**RE: LETTER TO ENVIRONMENTAL PROTECTION AGENCY (EPA)
REQUEST FOR DETERMINATION OF ADEQUACY AND COMPLIANCE REVIEW
Great Basin Unified Air Pollution Control District's
Final Determination of Compliance (FDOC)
Hidden Hills Solar Electric Generating System (11-AFC-02)**

**RE: REQUEST FOR DETERMINATION OF ADEQUACY AND COMPLIANCE REVIEW
Great Basin Unified Air Pollution Control District's
Final Determination of Compliance (FDOC)
Hidden Hills Solar Electric Generating System (11-AFC-02)**

I am contacting you regarding concerns about air quality and emissions related to the Final Determination of Compliance (FDOC) issued on August 1, 2012, by the Great Basin Unified Air Pollution Control District (GBUAPCD) for the Hidden Hills Solar Electric Generating System (SEGS).

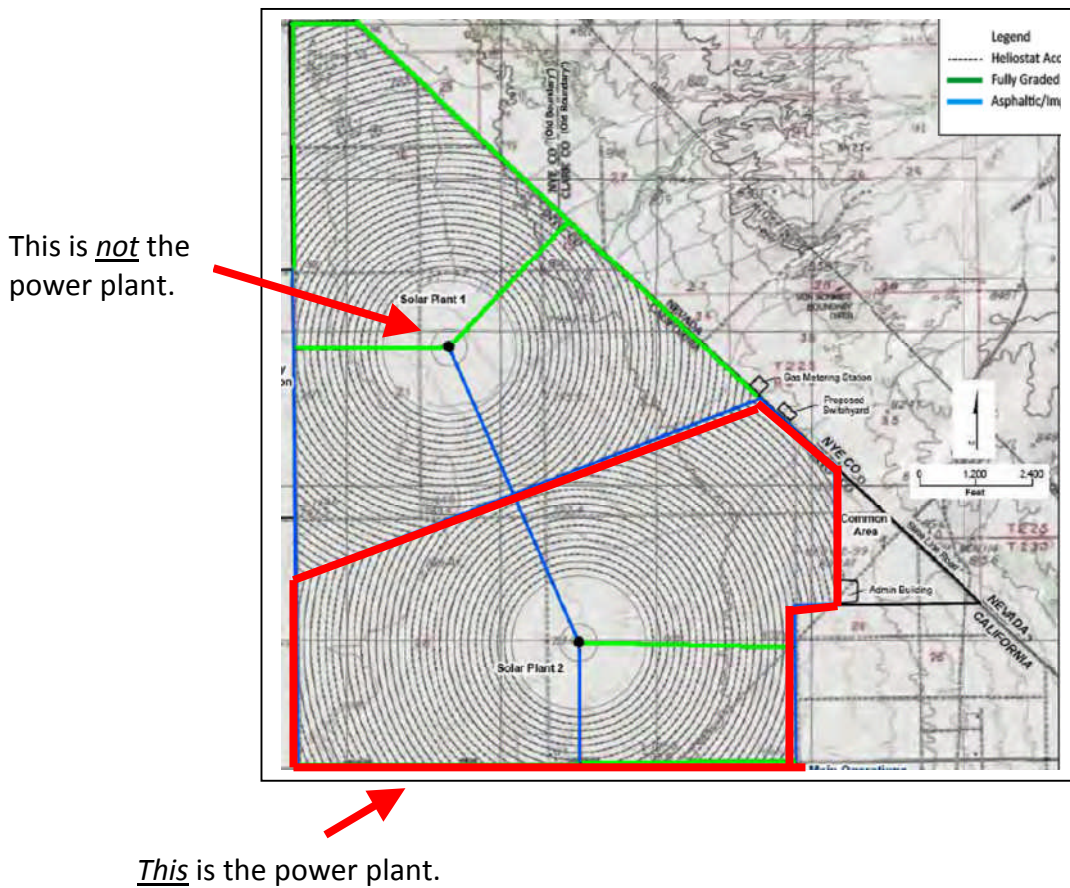
The fact that the heliostat/mirror assemblies are an inseparable component of power plant operations is clearly described in the CEC Preliminary Staff Assessment for the HHSEGS, where Staff specifically states that the heliostat/mirror fields are an inseparable part of the power plant as described below.

"Additionally, because the plant would consist of two independent steam turbine generators and many rows of heliostats, maintenance could be scheduled during the times of the year when the full power output is not required to meet market demand, which is typical of industry standard maintenance procedures."⁽¹⁾ [Emphasis added.]

The heliostat/mirror assemblies are stationary components of the power plant's facility wide design that surround each power tower, meaning they are anchored into the ground and focus the sun's radiation to the SRGS's located on top of the power towers.
